Final General Re-Evaluation & Environmental Report for Proposed Project Modifications

**Guadalupe River Project
Downtown San Jose, California**

Volume 2A
February 2001
SCH#199902056
Filed with U.S. EPA April 2001

**Integrated General Re-Evaluation Report/
Environmental Impact Report-
Supplemental Environmental Impact Statement for
Proposed Modifications to the Guadalupe River
Project, Downtown San Jose, California**

Figure 1 : Decision tree for onsite soil reuse and disposal based on soil mercury concentrations.

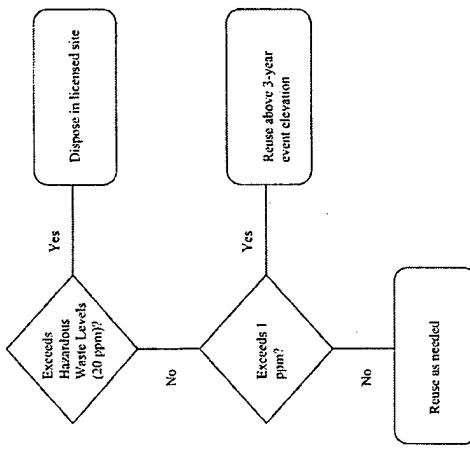
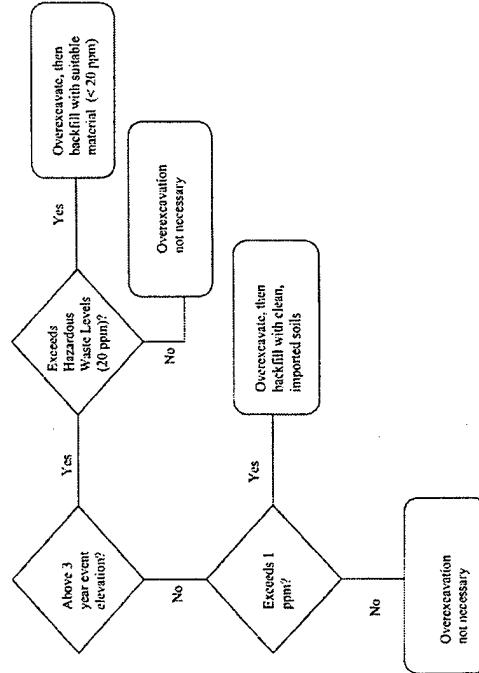
We agree with the overall approach stated in the SMP (Figure 1 and Figure 2). If implemented as proposed, the projects should result in improvements to water quality with respect to mercury transport and bioaccumulation. Our only comments are:
